**SUBJECT:** CASE 59-DR-2001#2

**REQUEST:** Approve elevations for remodel of an existing bar/restaurant

**PROJECT NAME:** Acme Bar & Grill Renovation

**ATTACHMENT #4**

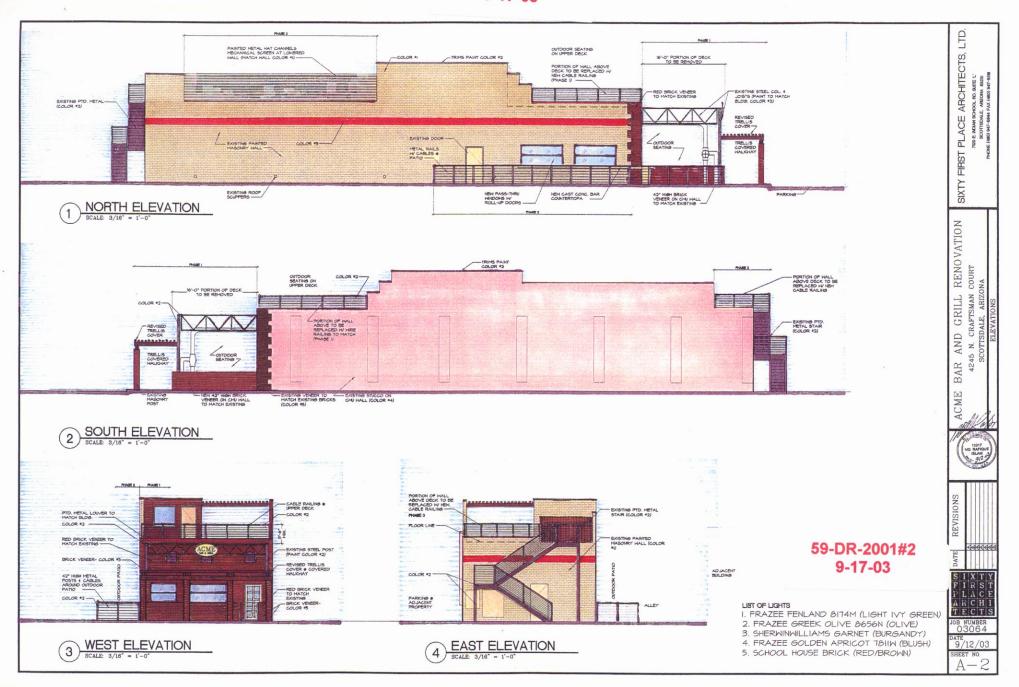
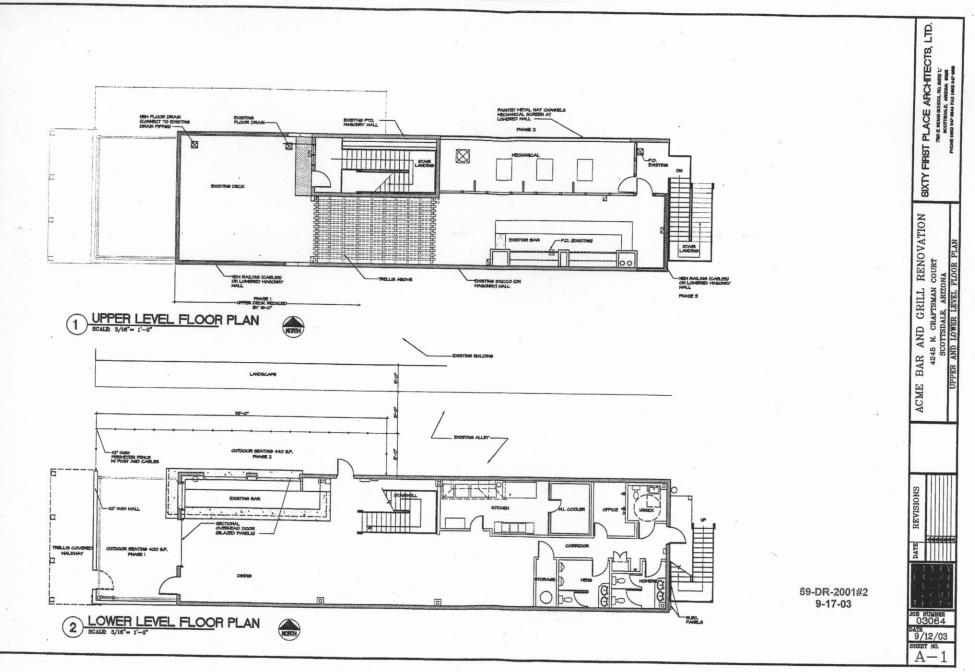
**DISCUSSION:** The proposed remodel will open the front 16 feet of the building to create a dining patio entrance into the bar/restaurant. The new front building face will have the same tumbled brick veneer previously approved for the building. The existing second floor patio will also be retracted and a new cable rail will be installed to increase visibility of the second floor to the street. The existing roof truss and a water pipe previously concealed by the building will be exposed. These exposed elements have been stipulated to be a steel gray color or match the olive-green color of the building. The existing shed arcade over the sidewalk will be modified into a flat trellis using the existing wood beams.

The applicant is also working with the City on using a portion of the 16-foot wide public alley as outdoor dining area, with a cable rail to separate the public and private spaces. The property owner to the north is also considering using a portion of the alley for outdoor dining. However, any proposed use of the public alley is dependent on a lease agreement with the City of Scottsdale and an agreement for Permission for Private Improvements in Public Right-of-way. The future use and design of the alley will require review and approval.

A. The proposed patio located in the 16-foot public alley is dependent on a lease agreement with the City of Scottsdale and an agreement for Permission for Private Improvements in Public Right-of-way. At the time of final plans submittal, the agreements shall be in place or the site plan shall be revised to remove the patio from the alley.
